# TECHNICAL BULLETIN

**MODEL/DERIVATIVE:**  
Freelander

**Bulletin N°:** 0002  
**CDS. ref:** L8654bu  
**Issue:** 2  
**Date:** 06.02.02

**PROBLEM:**  
**INCORRECT IDENTIFICATION OF GEARBOX FLUID LEVEL PLUG**

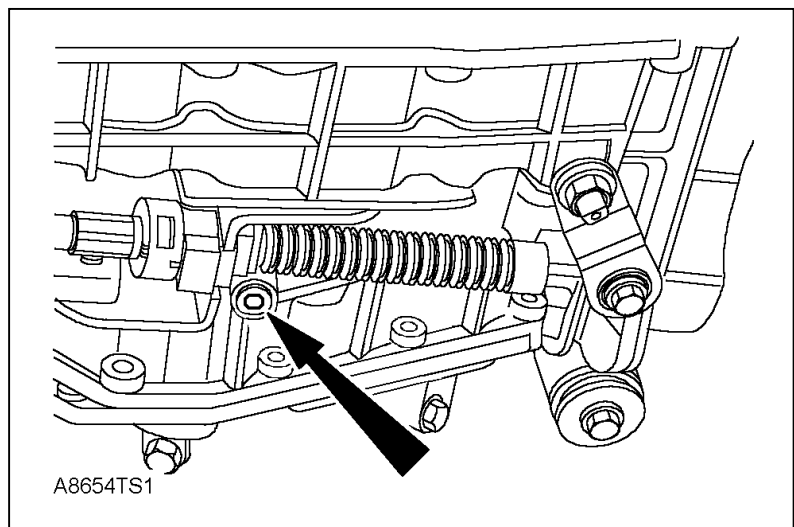
**CAUSE:**  
When checking the fluid level on the JATCO automatic transmission incorrect bolts are being removed / loosened, causing serious damage & malfunction.

- Removal of the reduction gear brake band bolt can cause total loss of drive or a substantial reduction in the performance of the transmission.
- Removal of the parking pawl rod plate retaining bolt (located next to the XYZ switch) will result in gear selection problems / gear lever movement restrictions.

Under **NO CIRCUMSTANCES** must these items be removed or loosened - doing so will invalidate any warranty claim made. In normal service, only the fluid level plug and fluid filler plug should be removed.

**ACTION:**  
The level plug (arrowed) is fitted vertically into the underside of the gearbox casing, alongside the selector cable bracket and can be identified by its 5mm Allen socket head.

The level plug closes the lower end of an internal level tube, therefore only excess fluid will be expelled when the plug is removed.

M44 1644

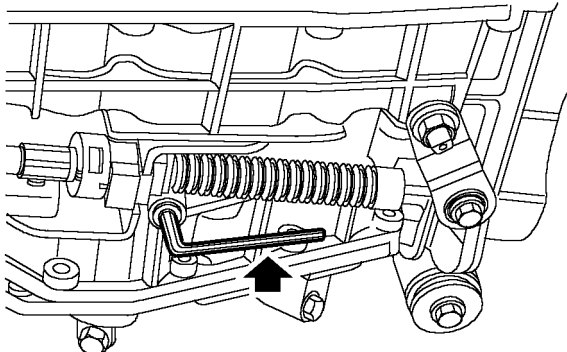
**CAUTION:** There are a number of similar fixings/plugs on the underside of the gearbox. It is imperative that the correct plug is removed prior to checking the level. Removing the wrong fixing/plug could result in internal damage to the gearbox.

7. With the engine still running, remove level plug using a 5 mm Allen socket and allow any excess fluid to drain off.

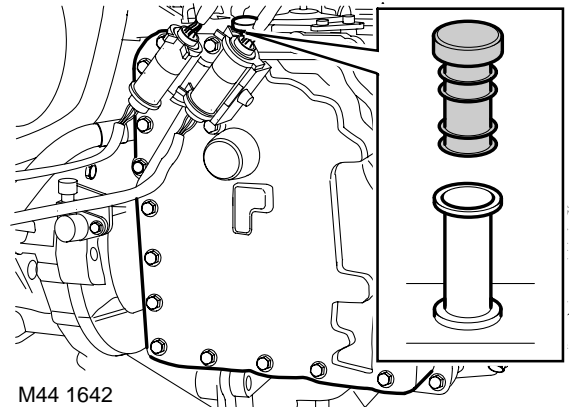
**CAUTION:** When topping up after a new air blast cooler (Td4 hot climates) has been fitted, an extra 420 cc of fluid is required. The fluid must also reach a temperature of 80° C (176° F) to allow the switch on the cooler to open.

2. Remove filler plug and add fluid until it just runs from level plug aperture.

3. Move selector lever from 'P' through each gear position and return to 'P', allowing any excess fluid to drain off.
4. Fit new level plug and tighten to 14 Nm (10 lbf.ft).
5. Clean and fit filler plug.
6. Disconnect TestBook.
7. Fit underbelly panel.
